UNIVERSITY OF GLASGOW
 DEPARTMENT OF PHYSICS & ASTRONOMY
 INSTITUTE FOR
 GRAVITATIONAL RESEARCH

Project
 LIGO II QUAD

Drawing Number
 L019

Drawing Name
 9 degree clamp for Mn blades

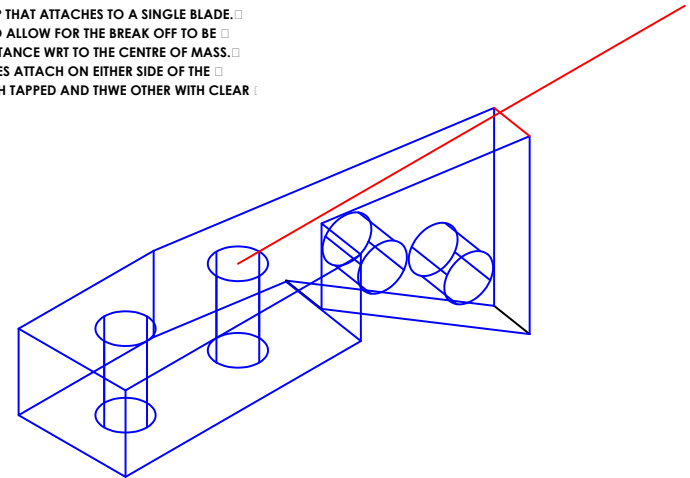
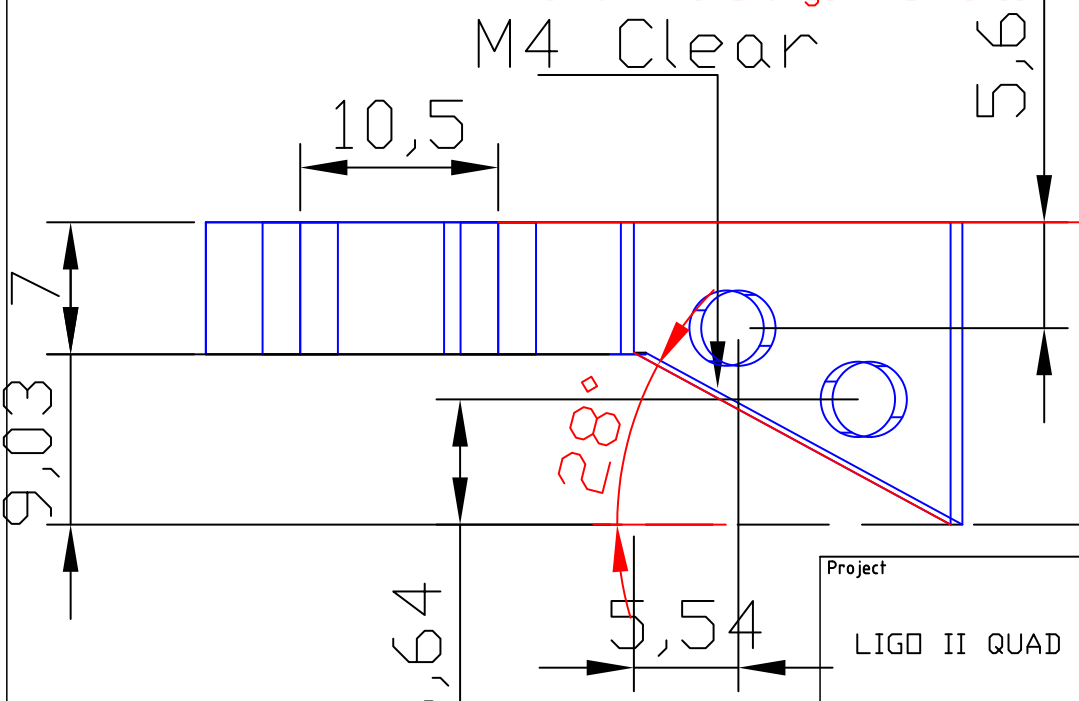
I want to change this to 10mm
